Standards Committee

Meeting Agenda

TITLE	Champion
1st time to Committee. Twenty (20) proposed drawings and revisions to WVDOH Standard details Book – Volume 2. The sheets are listed below. A summary of each sheets revisions are included in the meeting packet; and proposed sheets have revised areas highlighted yellow. a) <i>TE1-3A Roadside Sign Supports Steel Beam Type</i> b) <i>TE1-3B Roadside Sign Supports Steel Beam Type</i> c) <i>TE1-3C Roadside Sign Supports Steel Beam Type</i> d) <i>TE2-1A Bridge or Retaining Wall Sign Mounting, Type K 1 & 2 Supports</i> e) <i>TE2-1B Bridge or Retaining Wall Sign Mounting, Type K 1 & 2 Supports</i> f) <i>TE2-2 Bridge or Retaining Wall Sign Mounting, Type L Pipe Post Mount</i> g) <i>TE2-3 Barrier Wall Sign Support Bracket Type D</i> h) <i>TE3-1 Overhead Sign Support – Steel Two Tube Span (TTS)</i> i) <i>TE3-2 Overhead Sign Support – Steel One Tube Span (OTS)</i> j) <i>TE4-3A Overhead Sign Support – Steel Double Arm Cantilever</i> k) <i>TE4-3B Overhead Sign Support – Butterfly Cantilever</i> l) <i>TE4-4A Overhead Sign Support – Single Arm Cantilever (Heavy)</i> m) <i>TE4-4B Overhead Sign Support – Single Arm Cantilever (Light)</i> n) <i>TE4-5

STANDARD SHEET TE2-3

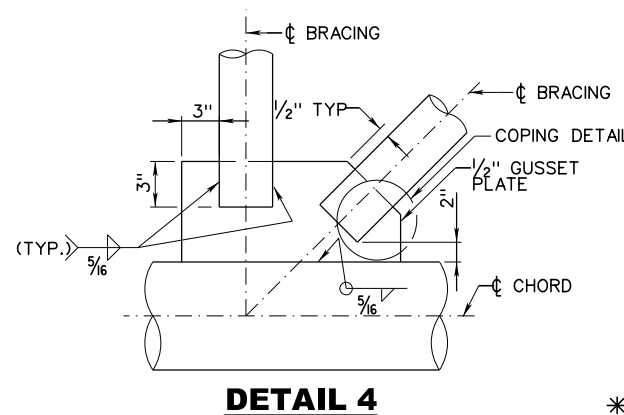
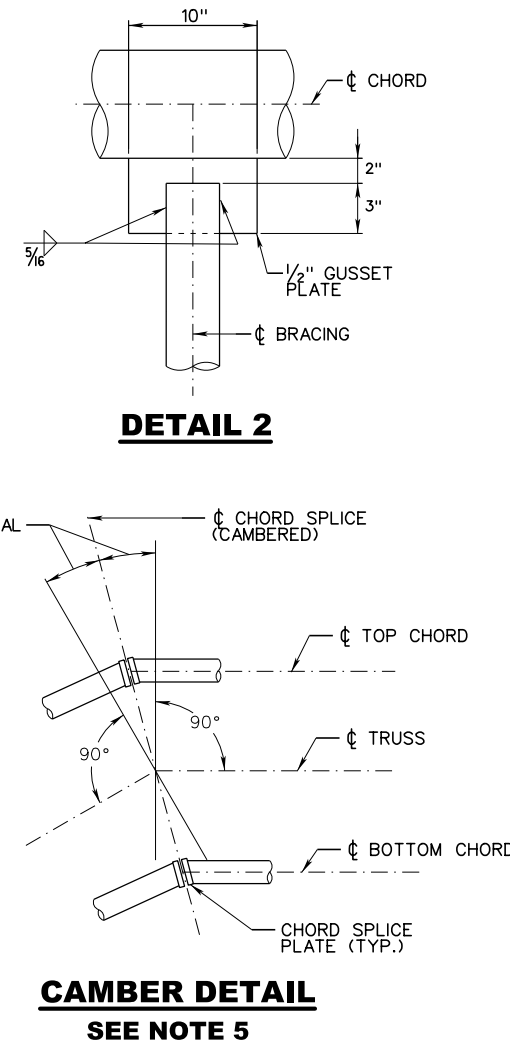
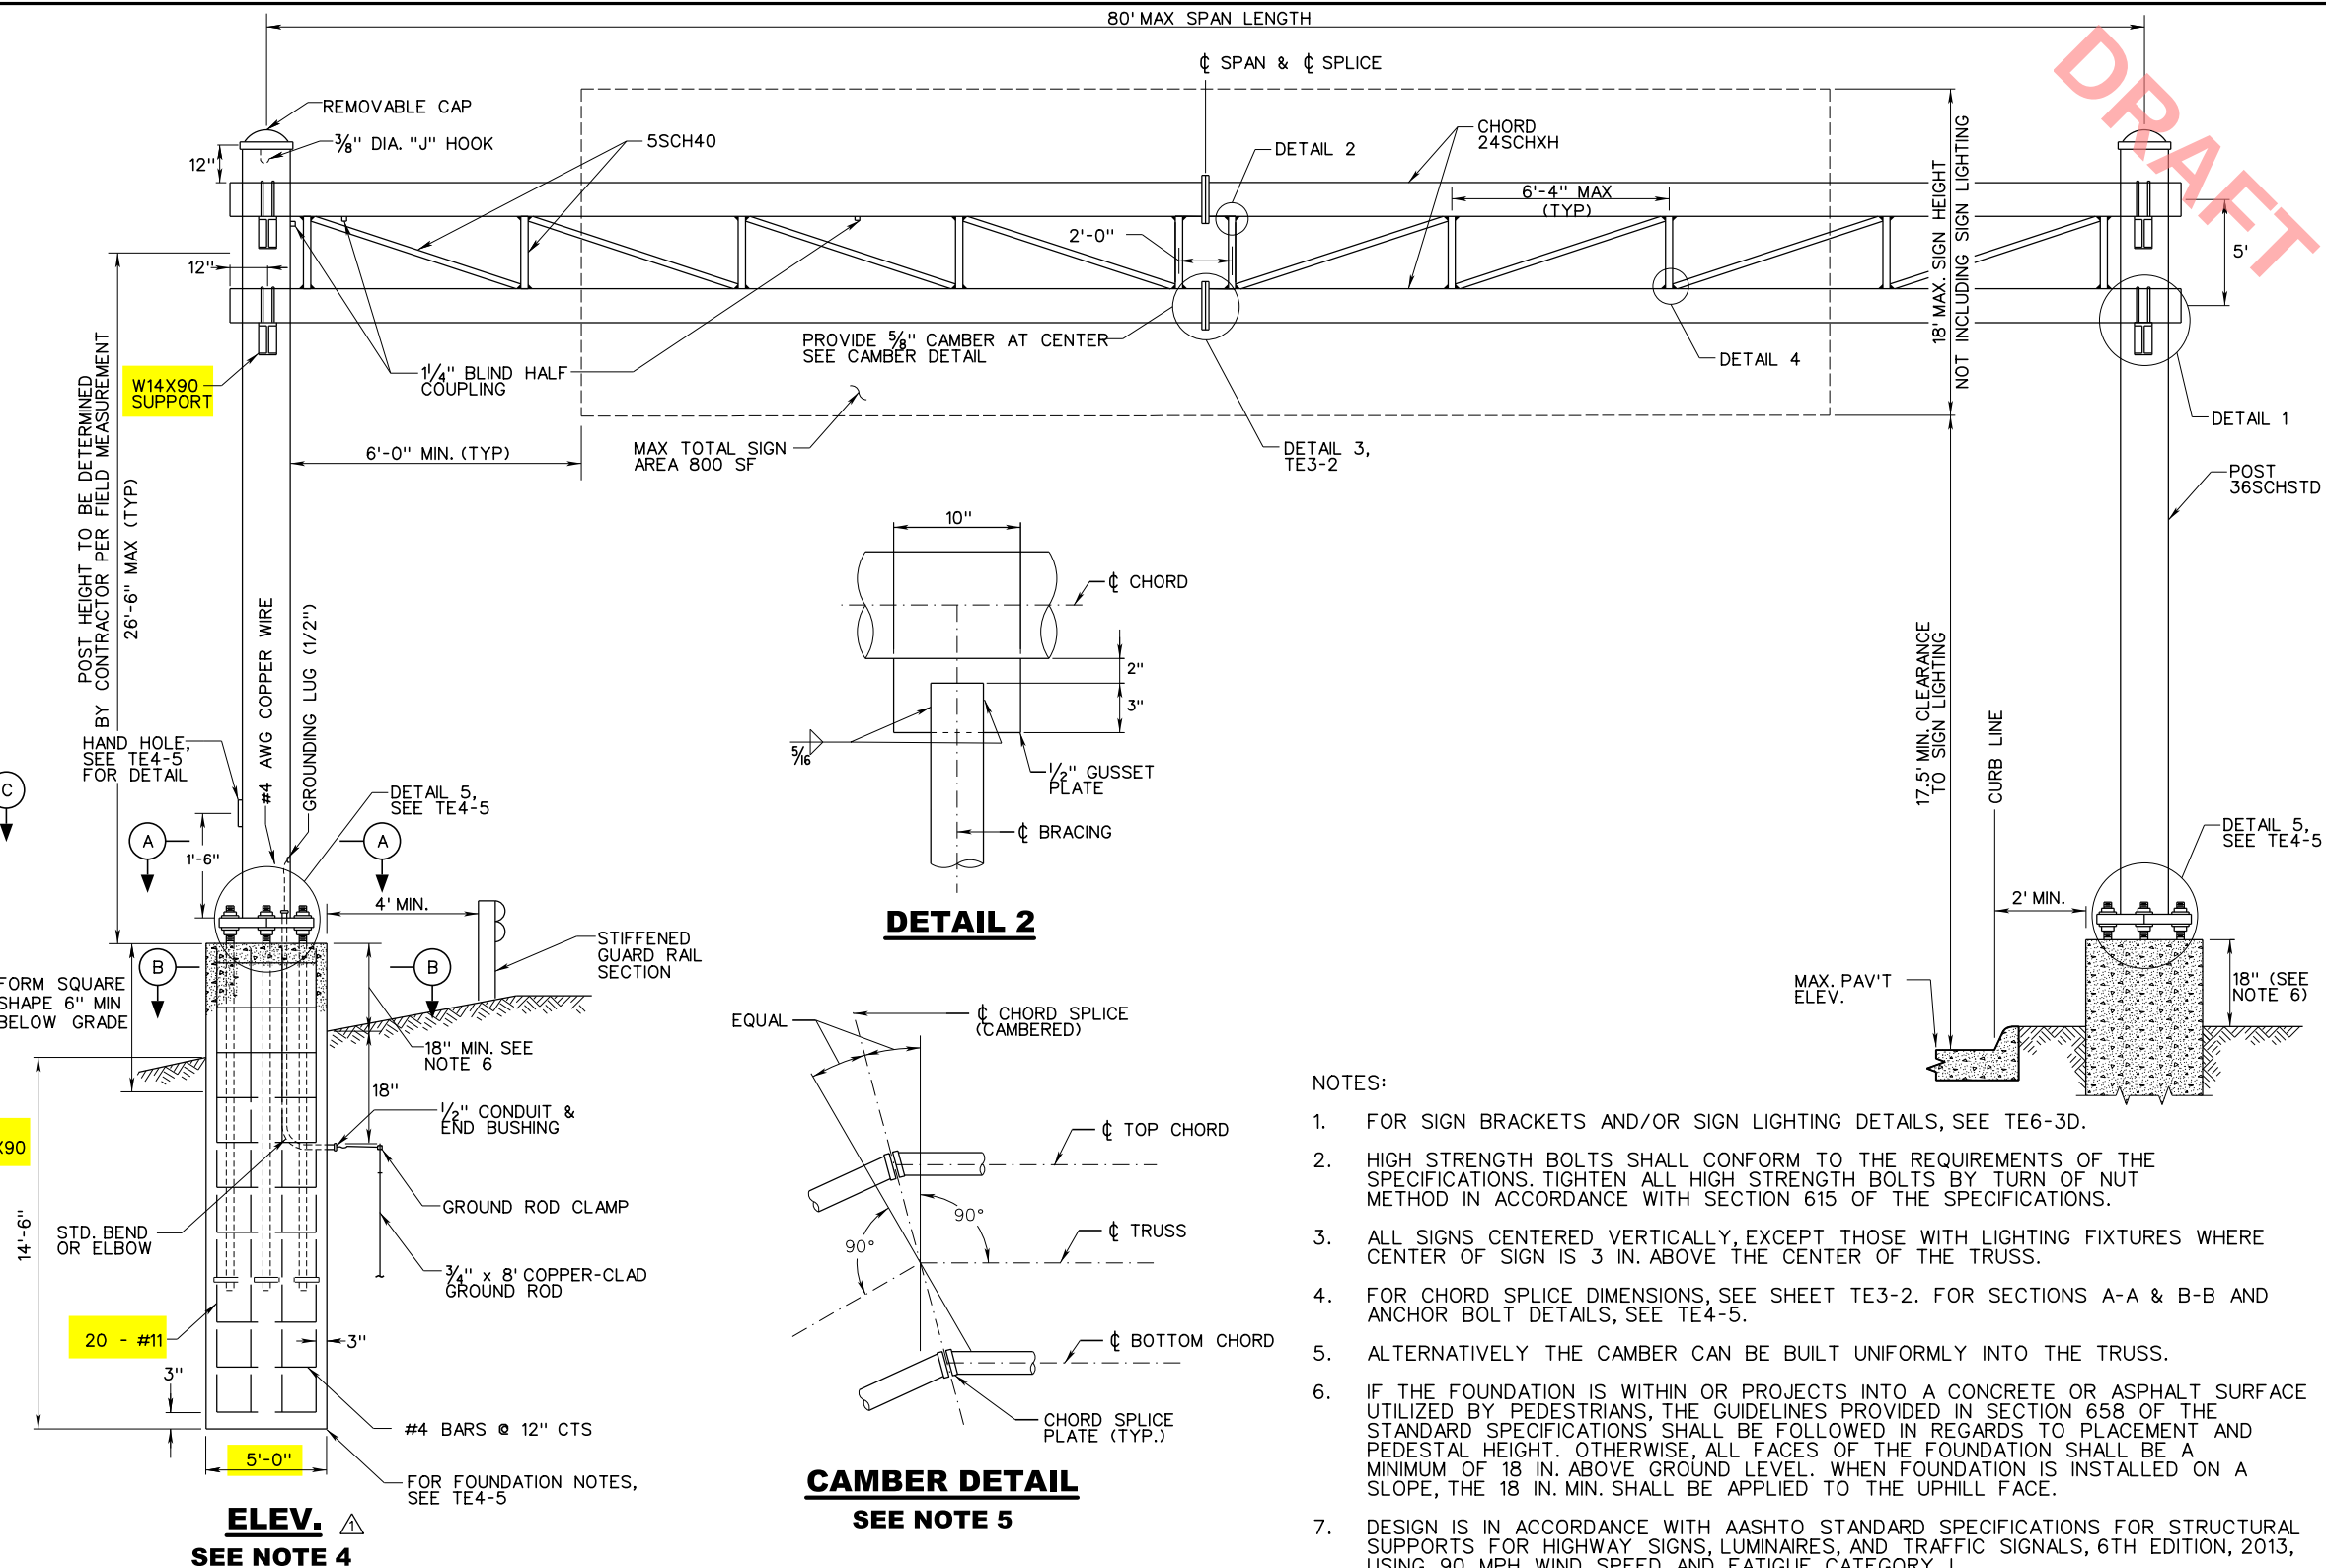
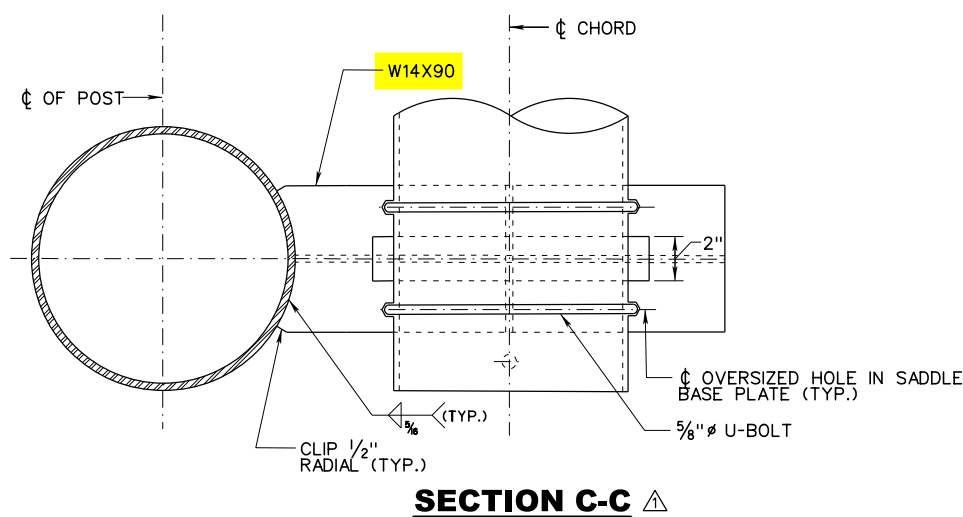
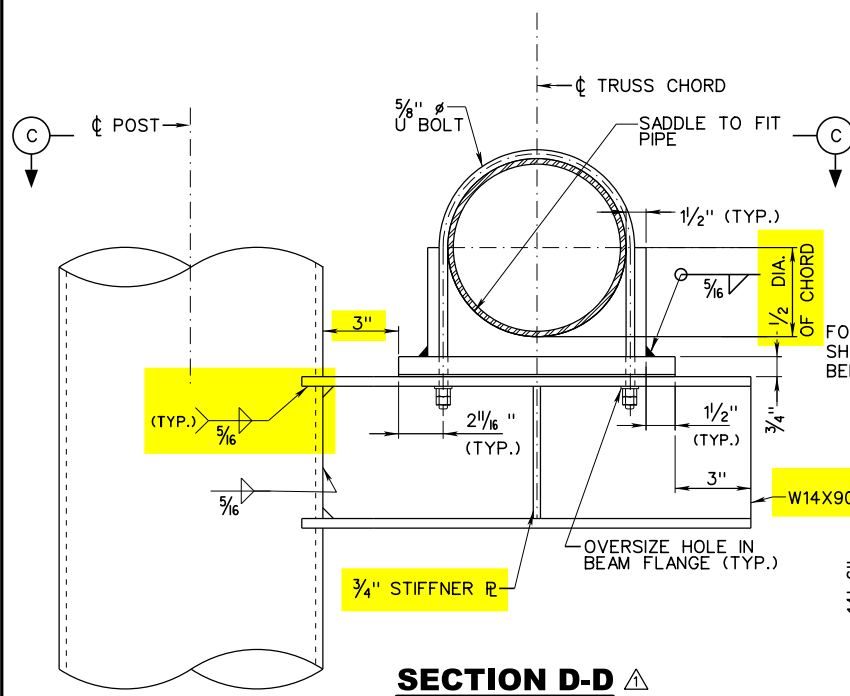
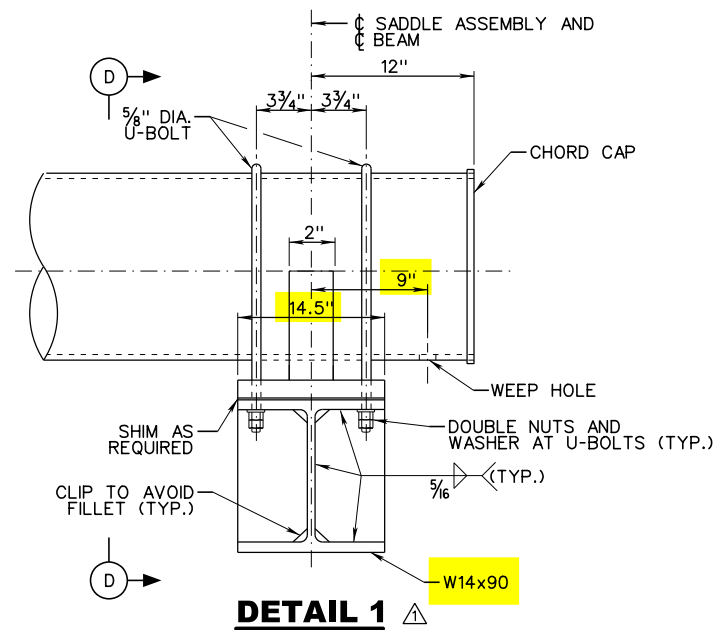
TE2-3	1	4/2022	Clarified the tubular steel post length to be based on TP3-1A.
TE3-1	1	2/22/2023	Increased the support bracket from W10X77 to W14X90 and revised associated dimensions. Added weld to flange portion of support bracket. Increased thickness of stiffener plate. Increased foundation diameter from 4'-6" to 5'-0" and number of vertical bars (See notes for TE3-2). Shifted Detail 4 and Coping Detail to make room for revision info.
TE3-2	1	6/2022	Added camber information to the sheet.
	2	2/22/2023	Increased the support bracket from W10X77 to W14X90. For TTS option, increased bolt circle (B) to 43" to meet the 1 1/2" clearance requirement between the nut and the post, which required the foundation diameter to increase. Decreased the S and F dimensions which previously were excessive. For the OTS option, increased bolt circle (B) to 26" to meet the 1 1/2" clearance requirement between the nut and the post. Increased the S and F dimensions. Increased the splice plate thickness (C) and added center hole diameter for base plate for both TTS and OTS types.

STANDARD SHEET TE3-1

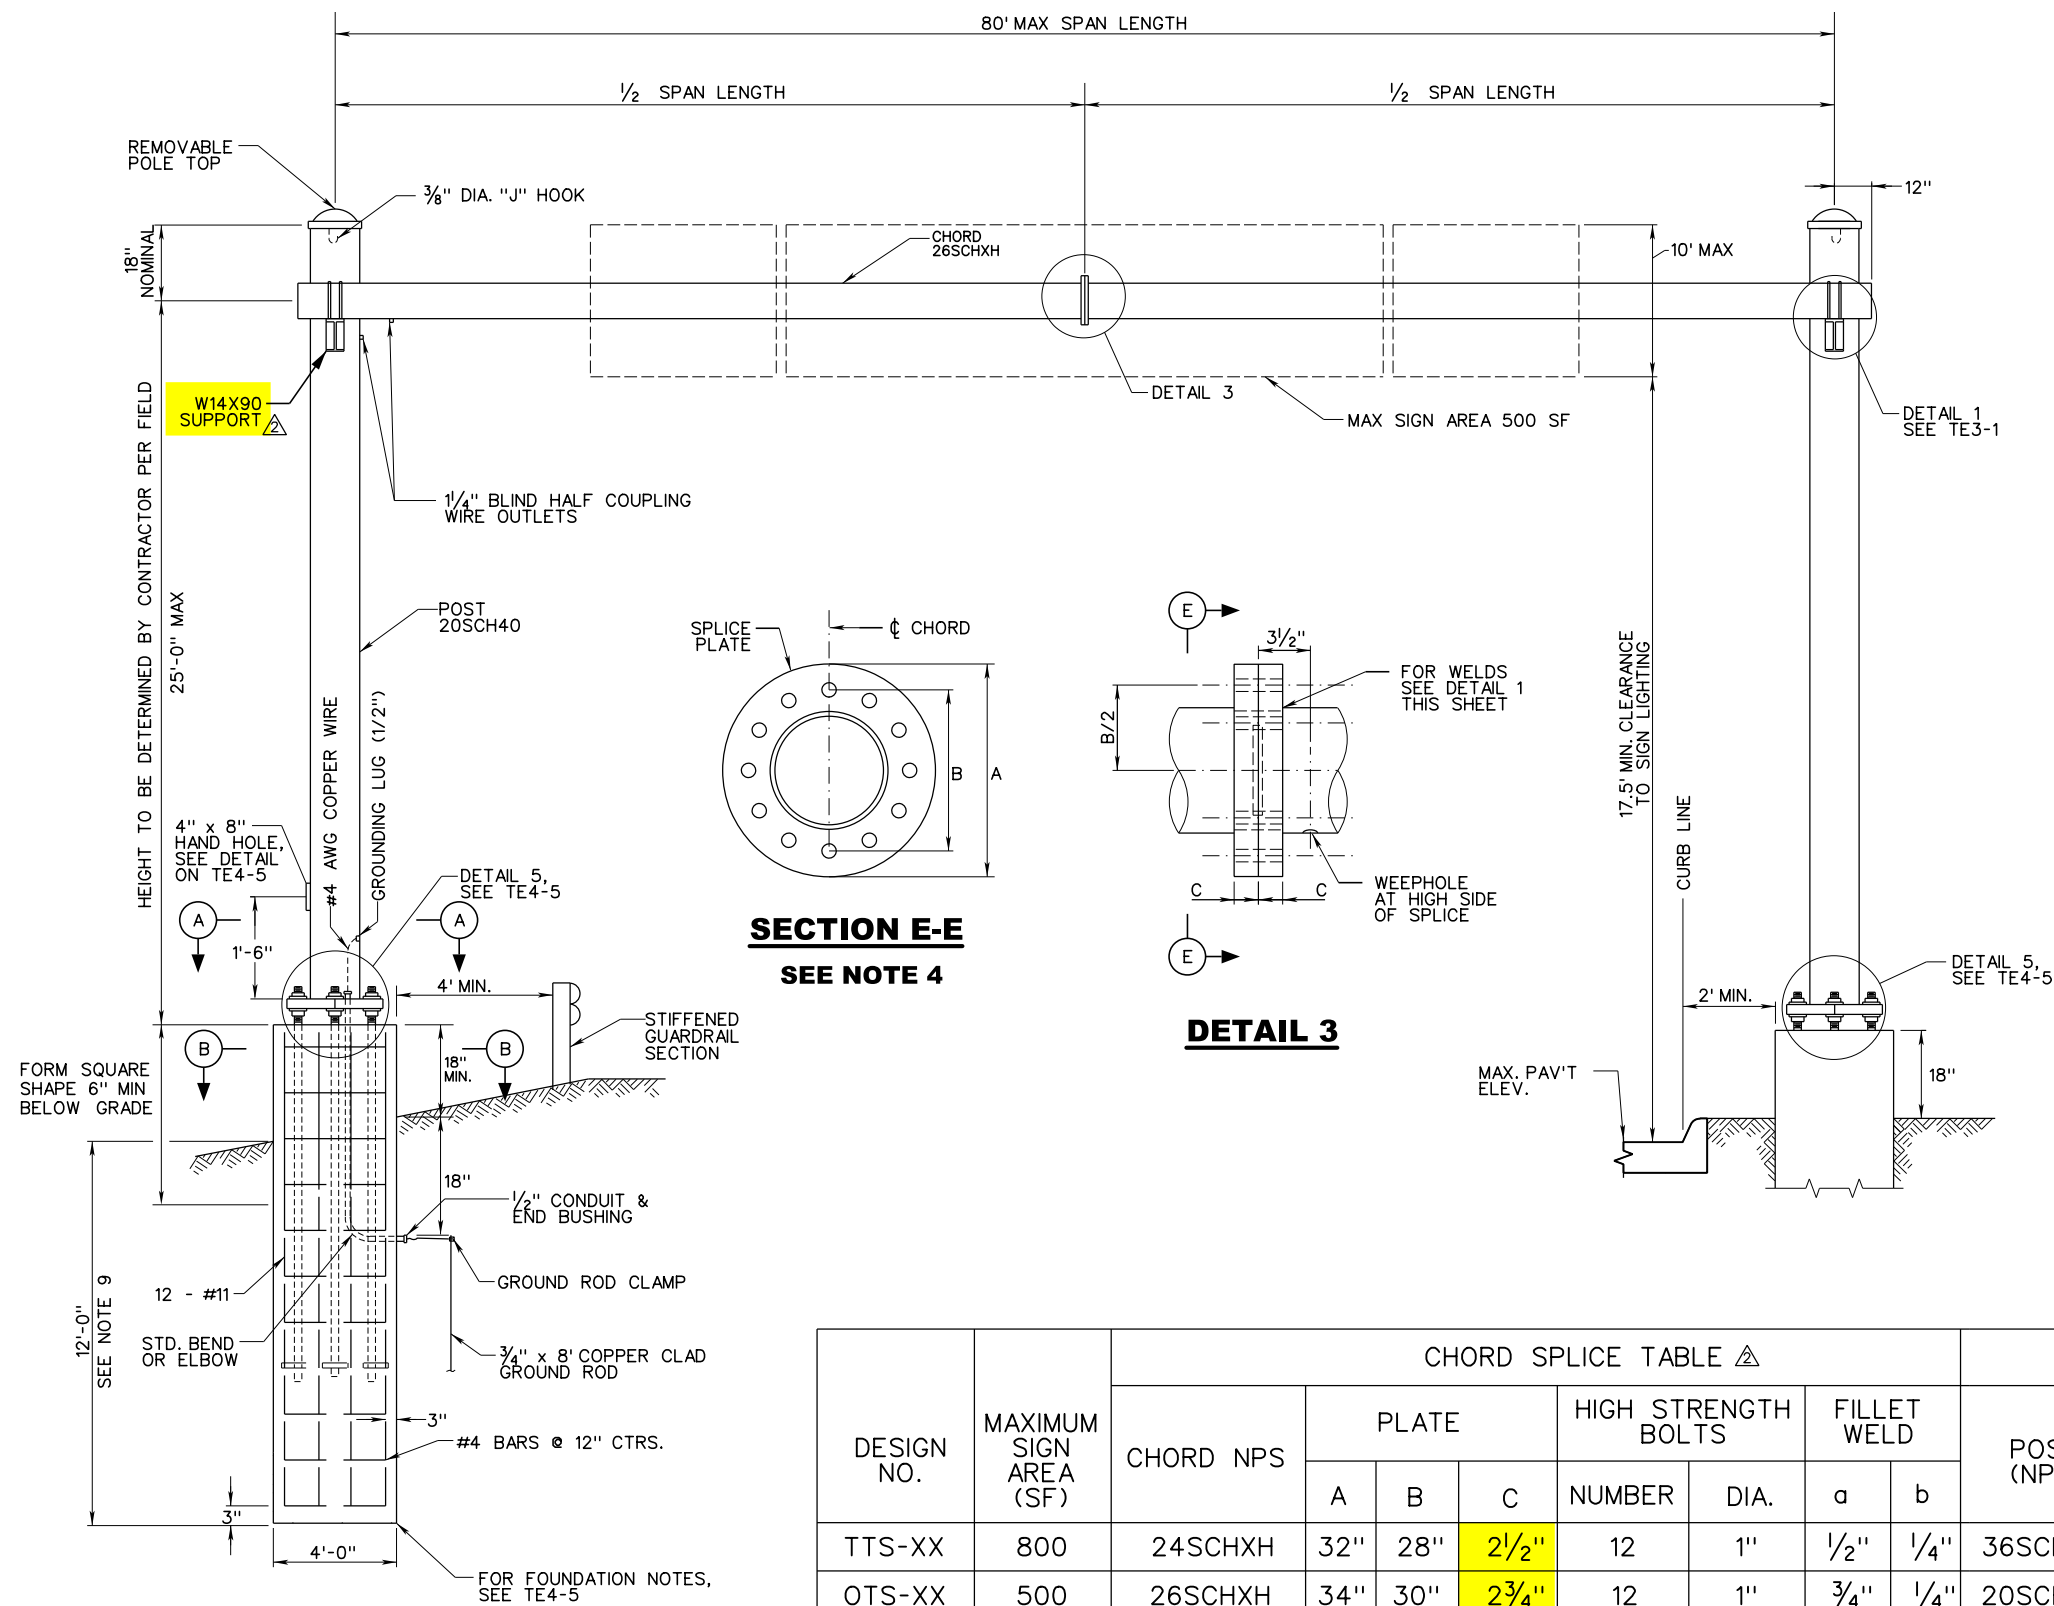
- ADDED CAMBER INFORMATION
 REVISED TABLE, REVISED BRACKET SIZE
